SEPTIC SYSTEM:

APPLICATION FOR INDIVIDUAL SEWAGE DISPOSAL SYSTEM PERMIT

Subject LUNDSFORD PERC TEST A.P. # 308-231-02

Subject: Percolation Test for Cisco Lundsford - A.P.# 308-231-02

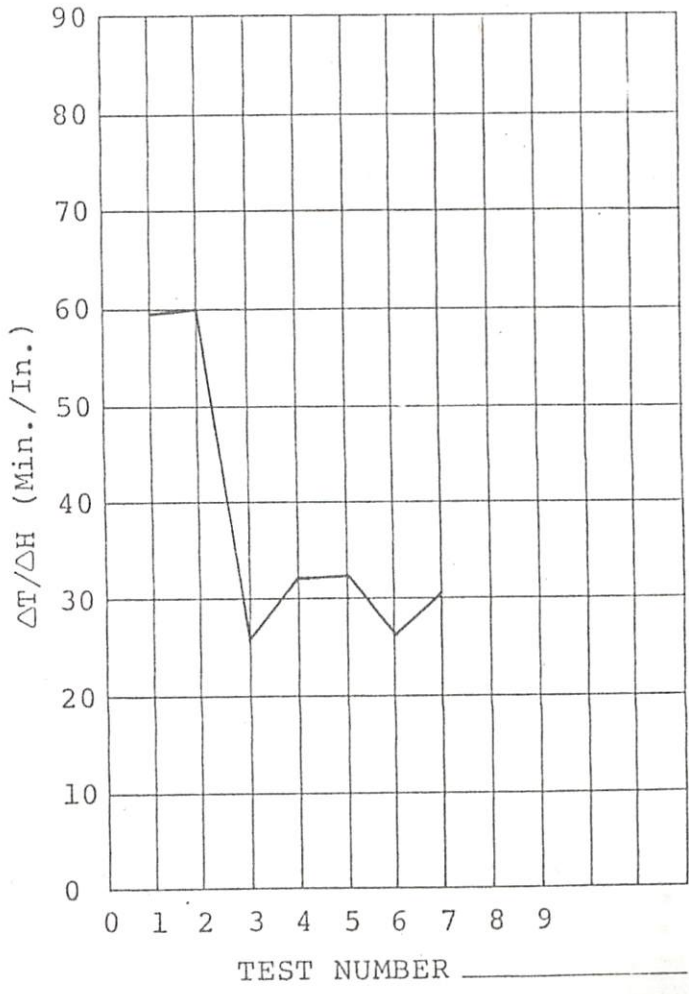
a meeting was held in my office
to review the percolation test results
submitted on this parcel - the
variations from our procedures ^{were}
discussed including hole size,
leaking test, measurement
method. Also reviewed the
skewed results on hole #4.
Reviewed profiles, texture
analysis and observed
sample of soil. Clark had
collected. Discussed type of
soil and location of
project. The conclusion
was that the percolation
tests were not properly
conducted and should
be repeated.

Subject LUNDSFORD PERC TEST A.P.# 308-231-02

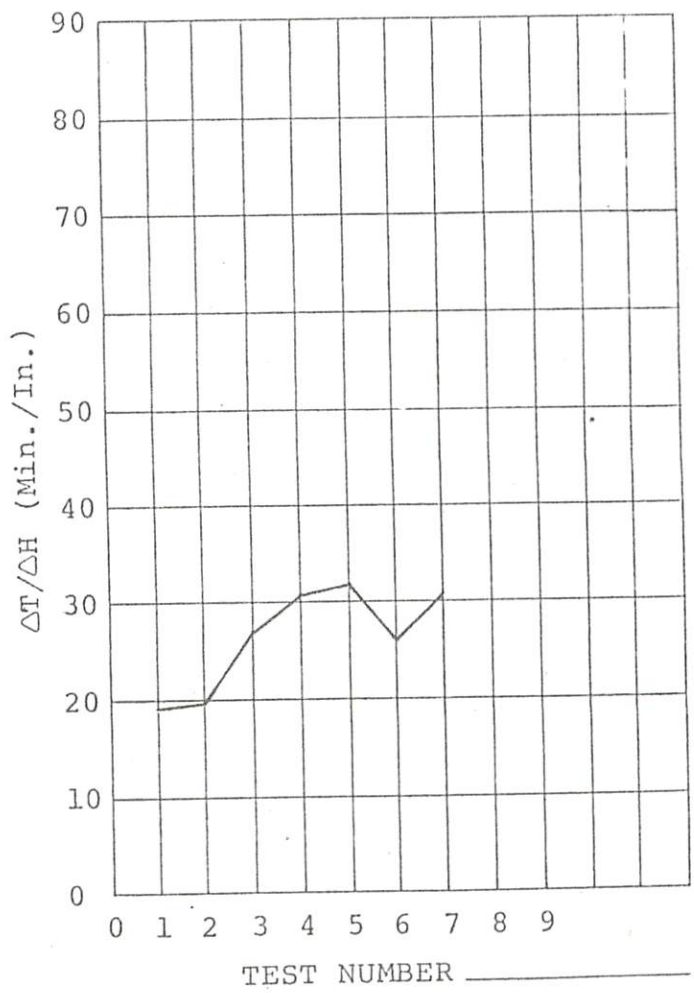
This is very interesting
why when 8" depth was
used per note dropped

I wonder how many holes
8" deep could influence note
Maybe 8" is not better when
air soil interface is near
testing level
